Subject: Class II Permissive Change for PCB and Part Modification and PAG C2PCPX

Product changes illustration and comparison

RF Board	
Before Changes	After Changes
 <p>RF board without shield (Top)</p>	 <p>RF board without shield (Top)</p>

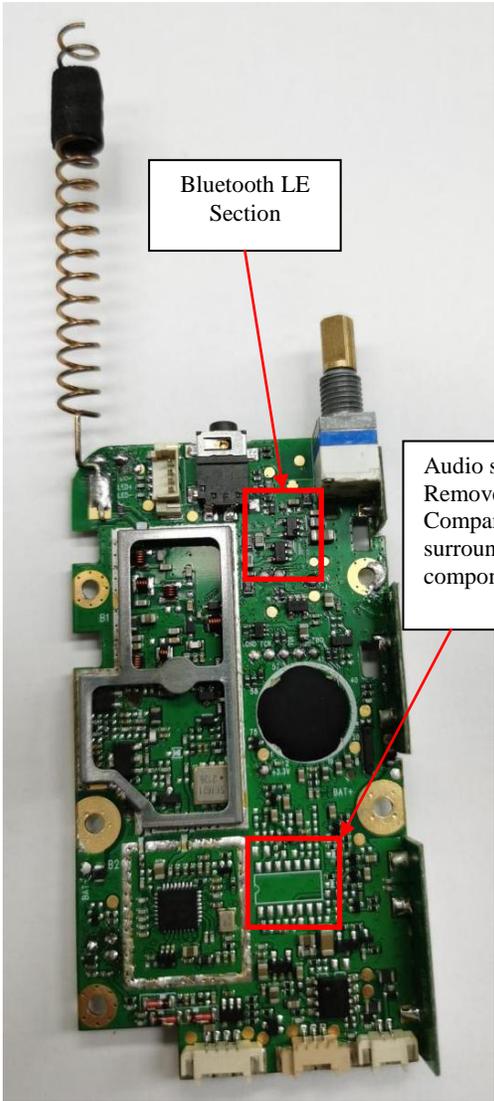
1. The changes were triggered due to BTLE chipset part shortage and a new BTLE chipset is replaced.
2. Few passive components were replaced at BTLE Circuitry due to new BTLE chipset part design requirement. All replacement parts performance are comparable to the existing parts.
3. A Comander IC and the surrounding passive components under Audio section are removed. The function of the Comander IC is to compress unwanted audio noise which does not impact the RF performance.
4. There is no mechanical change.
5. No change to the sales model number.
6. Reuse shipping batteries, chargers and accessories.
7. No changes to the RF section.

Bluetooth LE Section

RF Board	
Before Changes	After Changes
 <p data-bbox="272 1434 665 1470">RF board without shield (Bottom)</p>	 <p data-bbox="1016 491 1208 583">Bluetooth LE Section</p> <p data-bbox="1273 772 1536 961">Audio section: Removed the Comander IC and the surrounding passive components</p> <p data-bbox="919 1434 1312 1470">RF board without shield (Bottom)</p>
